Annex A

*Scheme Clarifications - Technical Clarifications about the major differences
between the PAS and the Present Scheme*

SUPPLEMENTARY CLARIFICATIONS FOR A/SK-TLS/64

Figure F2

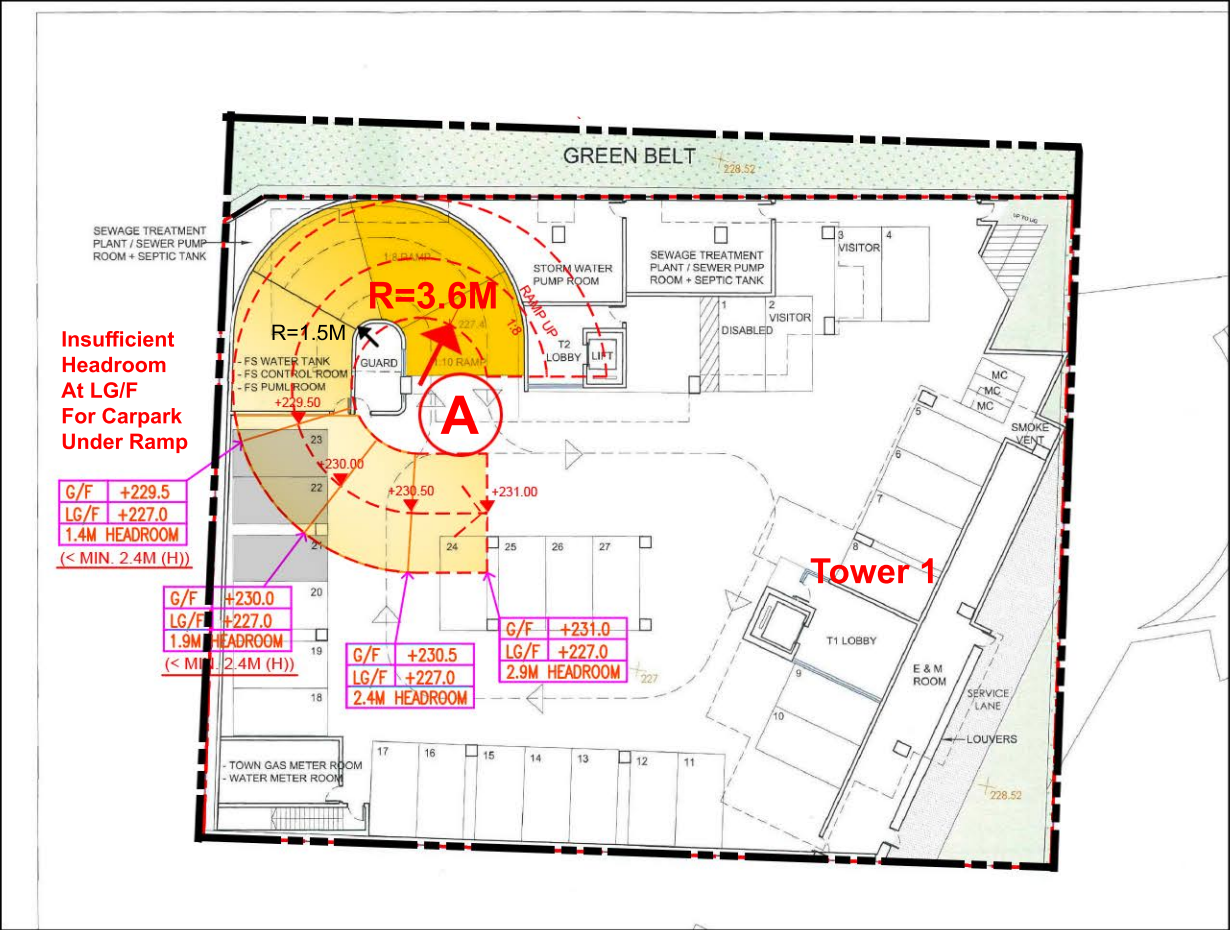
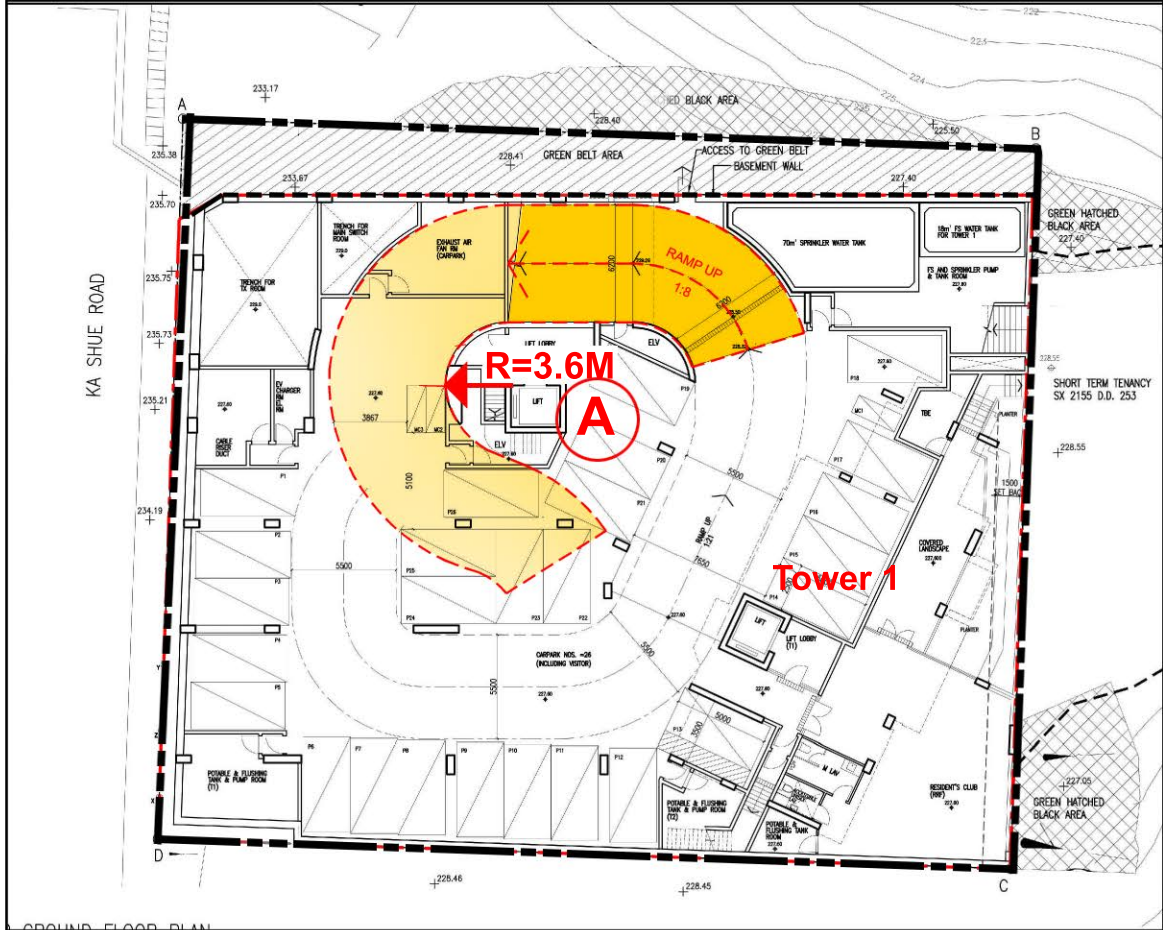
A.4. Insufficient turning radius of the driveway ramp of PAS as shown in **Figure F2**, according to the Access Roads/Driveways of PNAP APP-111¹ ‘Design of Car Parks and Loading/Unloading Facilities’. The minimum inner turning radius of a helical ramp should be not less than 3.6m for private cars. Therefore, the PAS scheme is unable to comply with this statutory building requirement.

A.5. The feasibility of a minor revision of the ramp in the PAS was also conducted, however, there will be insufficient headroom to comply with PNAP APP-111 and a reduction of 3 carparking spaces was also identified. As a result, the whole PAS scheme is unable to comply with the current car parking provision set out in the Hong Kong Planning

The Provided Inner Turning Radius is 1.5M, Less than Min. Turning Radius Required For Private Car (3.6M)

Following Correct Ramp Radius in Red Dotted Line, the Structure Adversely Affects the Headroom of Car-parking Area Below, Leading To Insufficient Headroom Resulting In Reduction Of 3 Nos Carparking Spaces

A. Sufficient Inner Turning Radius At Ramp
Now Complies With APP-111 (Min. Inner Radius 3.6M Provided).

Figure F3

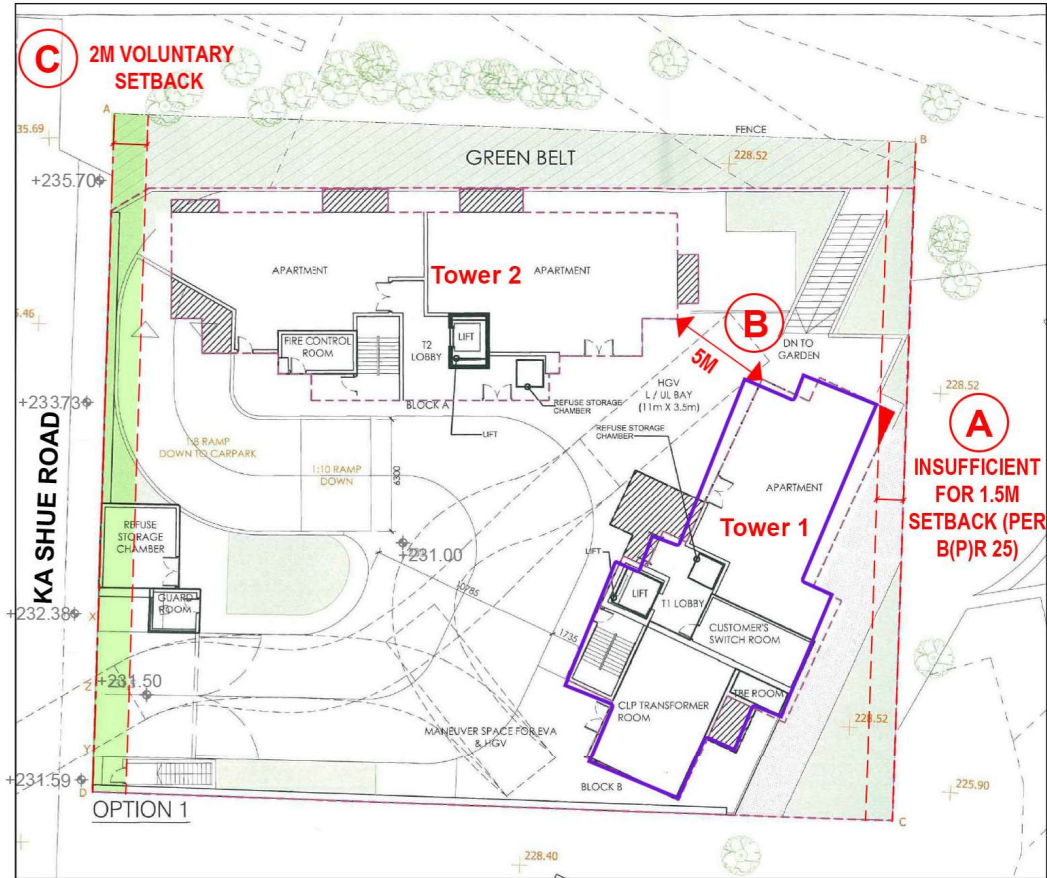
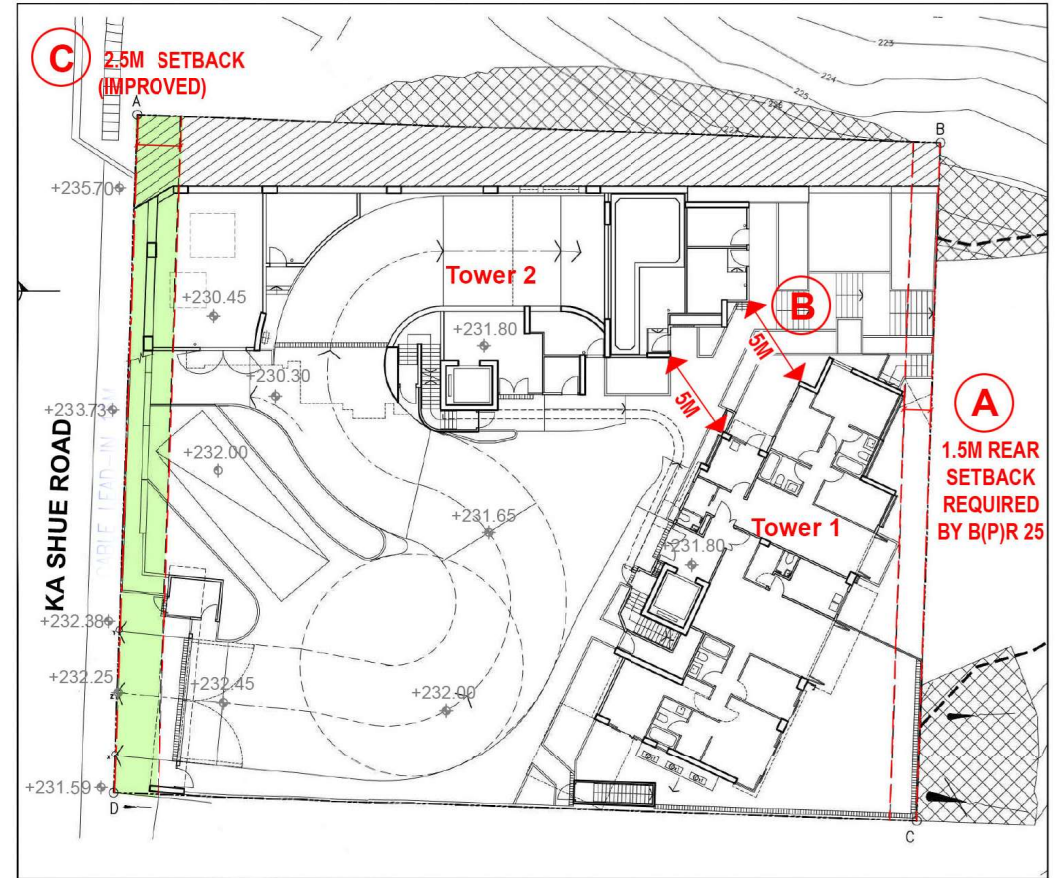
- A.6. The schematic Master Layout Plan of the PAS was failed to comply with the Building (Planning) Regulations 25(2) to provide a building setback of 1.5m at the rear boundary of the site, as shown in **Figure F3**. It should also be noted that the proposed 5m building separation between Tower 1 (“T1”) and Tower 2 (“T2”) (in the PAS) would be unachievable due to the repositioned T1 in the PAS as a way to comply with the provision of 1.5m rear boundary setback as stipulated in B(P)R 25 (**Figure F3**).
- A.7. In order to comply with the Building (Planning) Regulations 25(2), T1 has been repositioned to comply with such requirement taking to account the provision of a minimum of 5m building separation between T1 and T2 (**Figure F3**).

**A. Not Comply With B(P)R25 ,
Setback Minimum Of 1.5M From Rear Boundary Needed**

**B. If Building Shifted ,5M Building Separation Between
Buildings Cannot Be Achieved**

**A. Complies With B(P)R25 ,
1.5M Rear Boundary Setback Provided.**

**B. 5M Building Separation Maintained,
By Revising the Building Shape
and Internal Layout of Apartments**

C. 2.5M Setback Provided

Figure F4

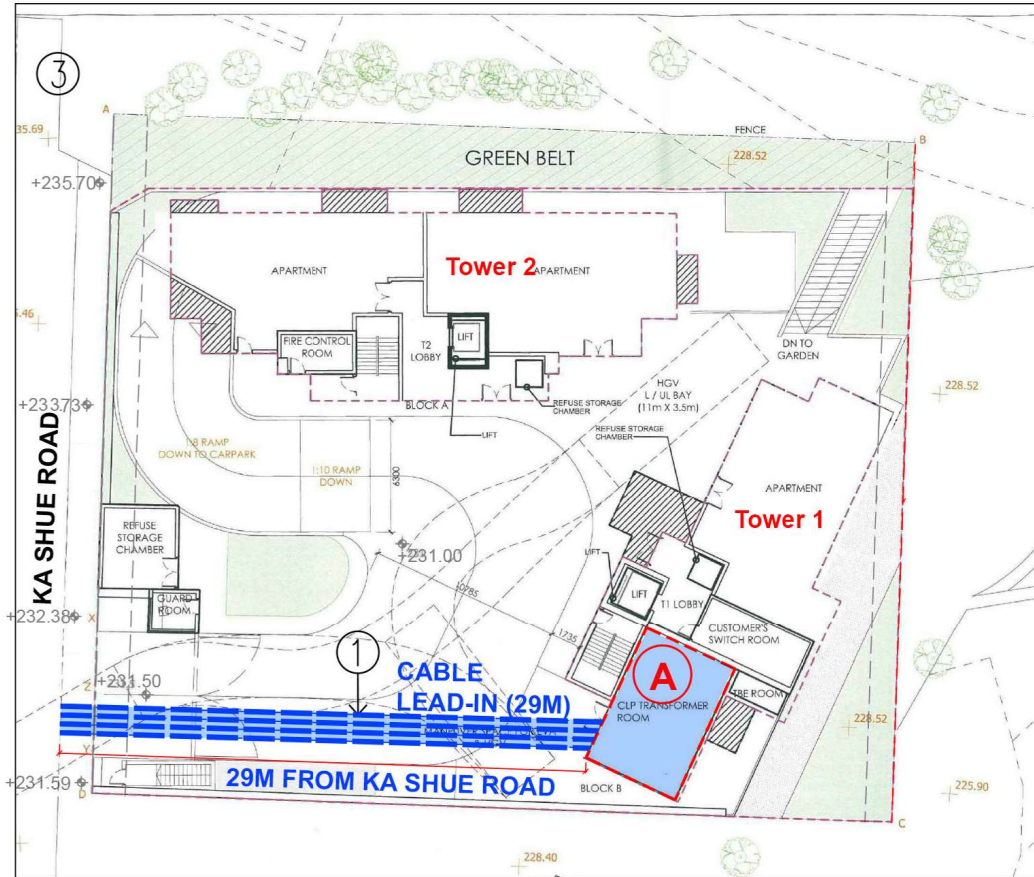
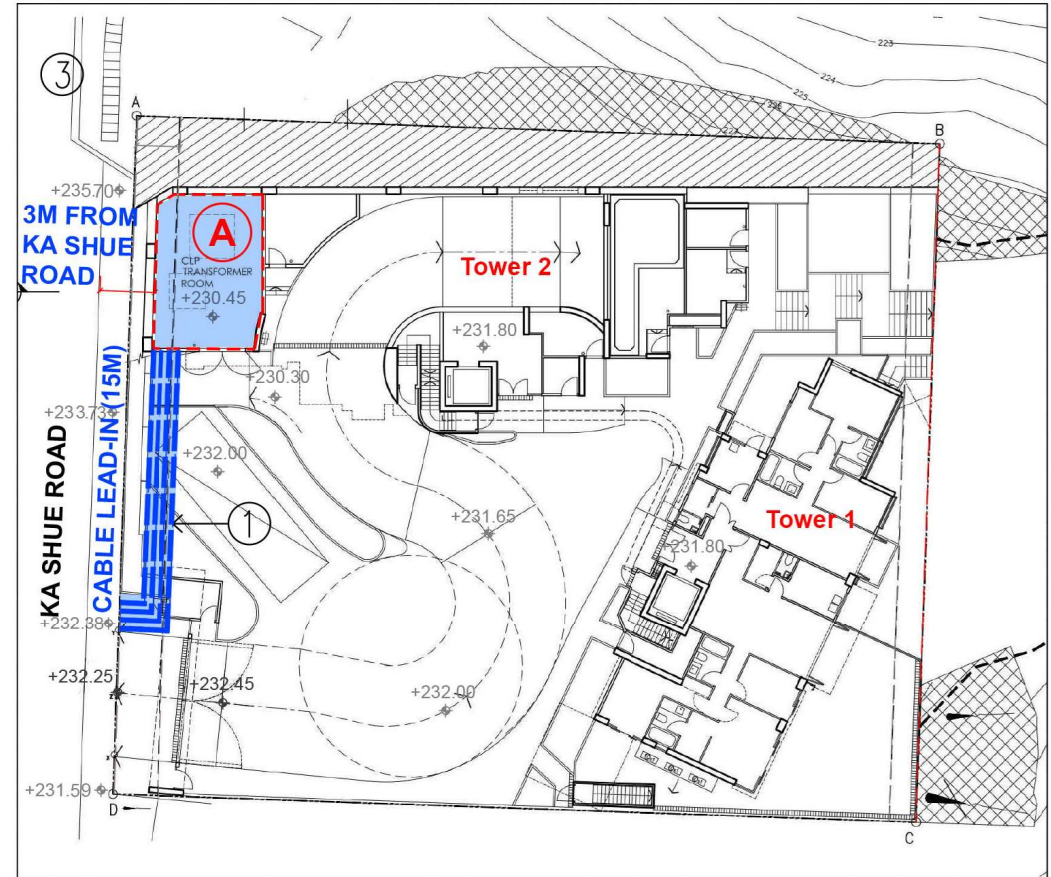
- A.8. Upon the approval of the application, the Project Team liaised with CLP regarding the location and technical requirements of the proposed transformer room. Based on the original scheme of the PAS, the feasibility of the proposed new TX Room at G/F in T1 is considered not acceptable as the cable lead-in duct is excessively long (i.e. 29m) and too away from major road (i.e. Ka Shue Road) as shown in **Figure F4**.
- A.9. Furthermore, in its replies, CLP found the proposed location to be non-compliant with ‘Code of Practice 101 for Distribution Substation Design (Version 15)’³ (“**CoP 101**”) and outlined clearly that the proposed development should, among other requirements, comply with the following:
- Locational requirements for the substation to be located at the periphery of the building (**Para. 5.1.2 of CoP 101**);
 - Minimum headroom of 3.6m (**Para. 5.1.5 of CoP 101**);

**CLP Prefers The Location Of A New Transformer Room Nearest Possible To Public Road ;
And Shortest Possible Length Of Cable Lead-in**

A.Cable Lead-in Is 29M Long And Away From Ka Shue Road , Not Preferred By CLP.

A.10. Having considered the specific location requirements set out in CLP's "Para. 5.1.2 of CoP 101" (**Appendix A**), the Project Team then recommends to relocate the new TX Room from G/F of T1 in the PAS to G/F of T2 in the present scheme, as shown in **Figure F4 and Figure F5**.

A.Cable Lead-in Is Only 15M Long And Only 3M Away From Ka Shue Road , Preferred By CLP.

Figure F5

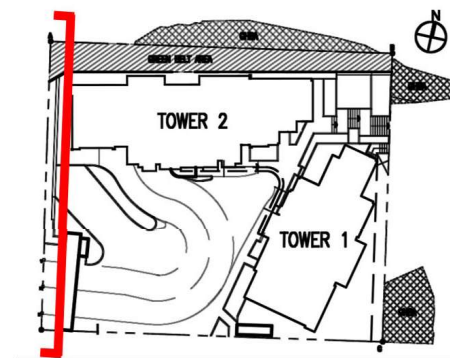
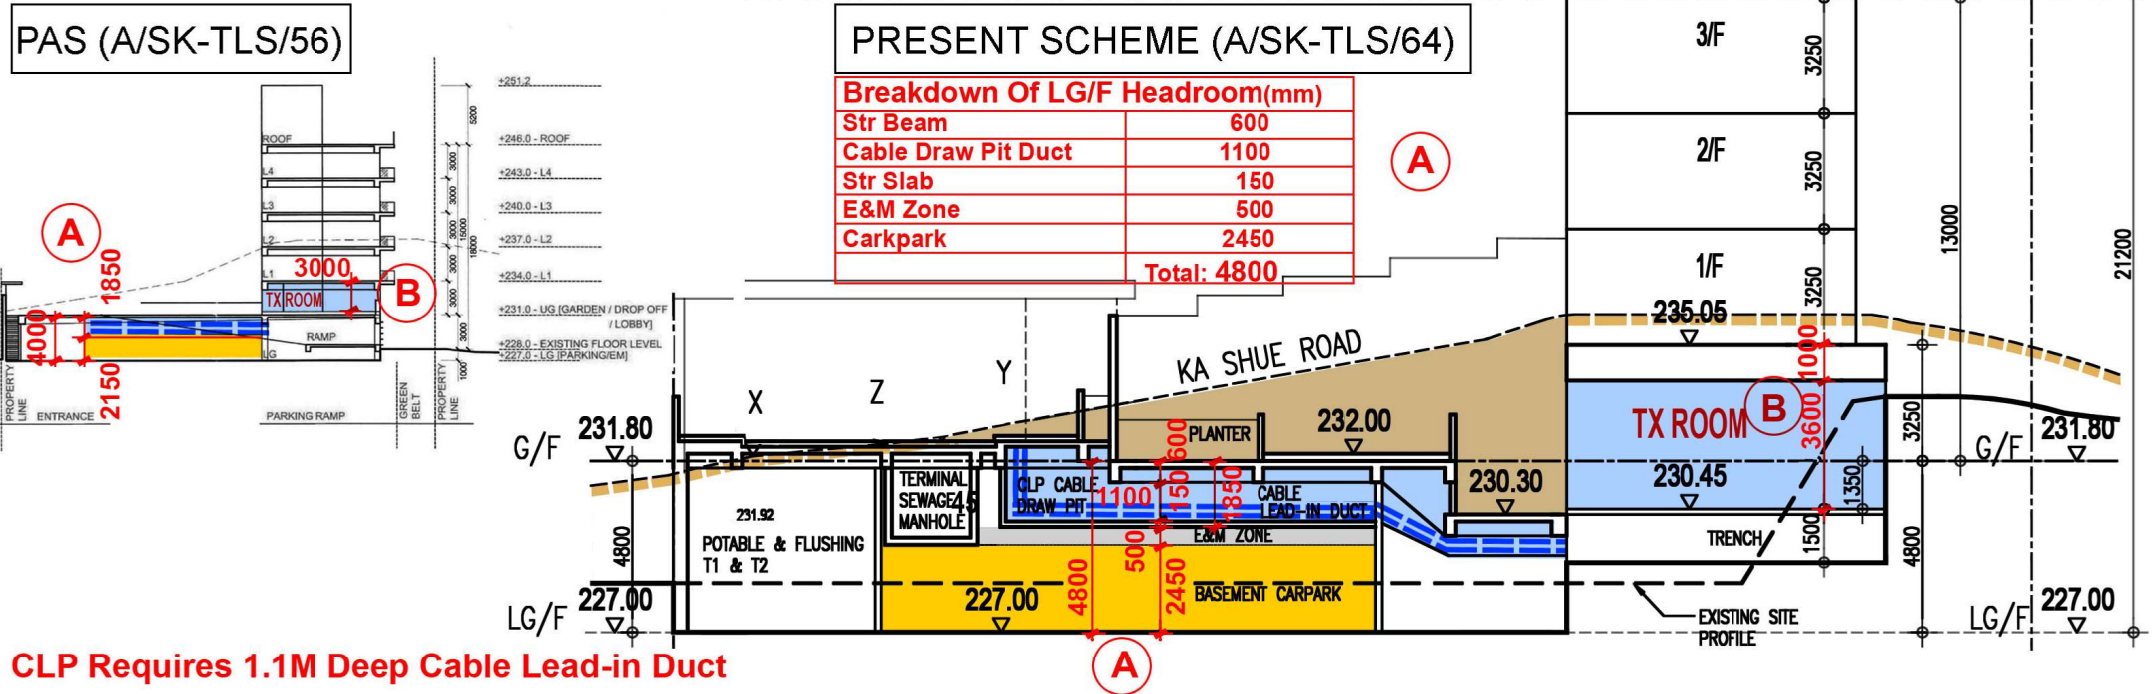
A.11. The new building height of 4.8m at LG/F is considered to be a reasonable floor height when a 1.25m cable draw pit duct including a 0.15m ancillary structure slab was required to be connected to the trench of the TX Room at G/F, a 0.5m E&M zone and a 0.6m structural beam. As shown in **Figure F5**, the remaining headroom for the LG/F of 2.45m would only be slightly above the statutory requirements set out in Cap. 123G.

A.13. As shown in **Figure F5**, a bare minimum building height ("BH") of 4.8m is required for the LG/F of T2. When compared to that in the PAS, it represents an increase of 0.8m.

1. The Relocation Of The Transformer Room
2. The Increased Height Of The LG/F
3. The Revised Levels Of The Transformer Room Ceiling Slab,
And The Raised Level Of 1/F Residential Flats.

Figure F6

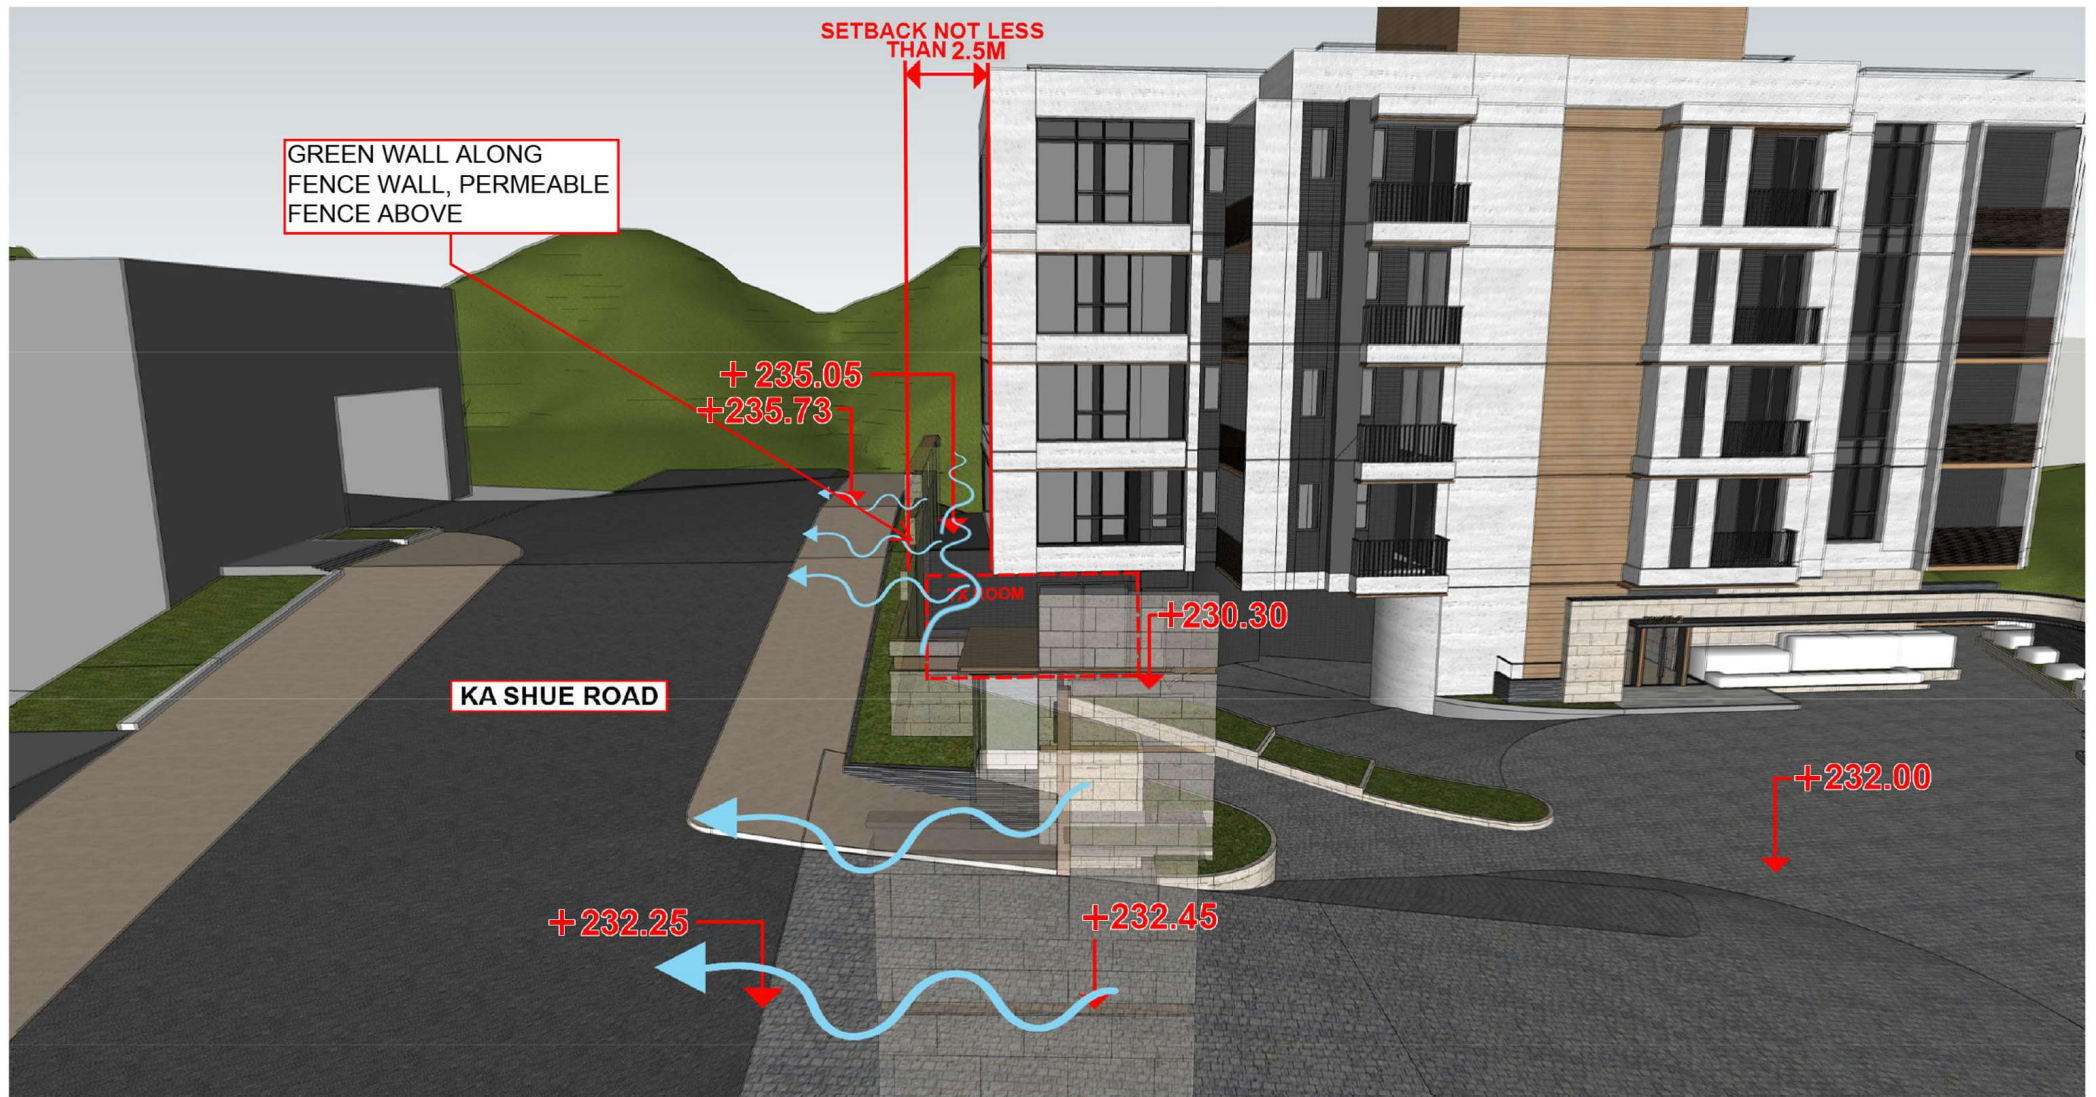
B.2. **Figure F6** is the artist impression diagram of the proposed building setback (currently not less than 2.5m wide) from Ka Shue Road illustrating to improve visual amenity and natural wind penetration along Ka Shue Road.
